Countries:	CANADA, UNITED STATES	Document ID:	IK1600177
Availability:	ISIS, FleetISIS	Revision:	3
Major System:	CAB / SLEEPER / HOOD	Created:	2/28/2013
Current Language:	English	Last Modified:	11/4/2013
Other Languages:	NONE	Author:	Patrick Gotschall
Viewed:	444

Title: SkyRise Roof Replacement

Applies To: ProStar Skyrise

Figure 3: New notch overlaid over old notch (red area should be removed).

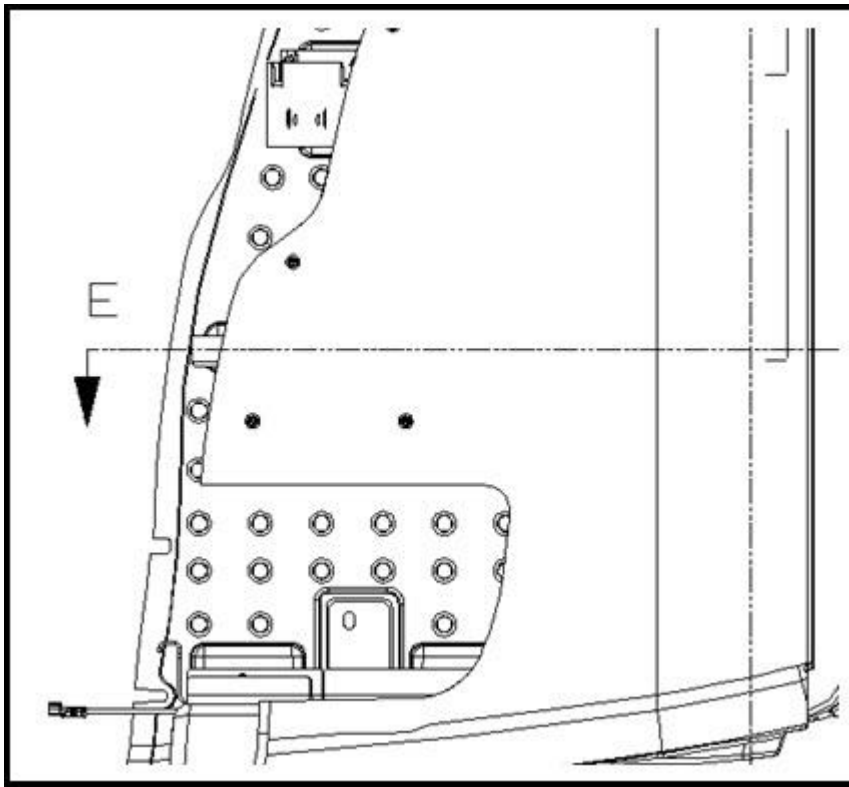
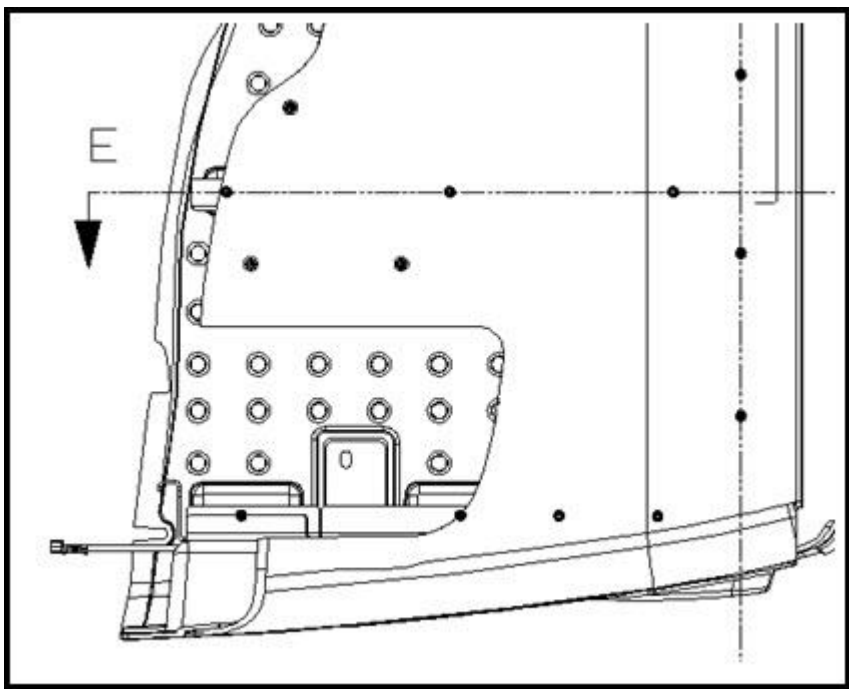
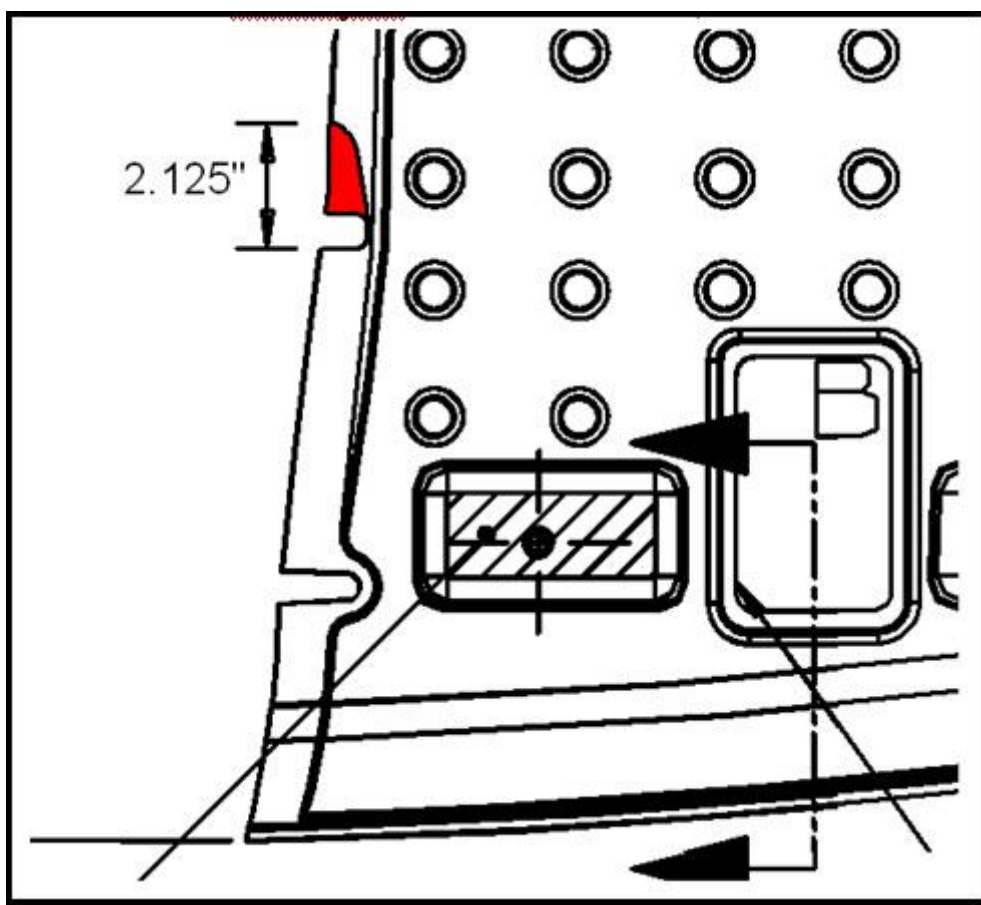
Cabinets should be modified to provide clearance to the roof reinforcement.
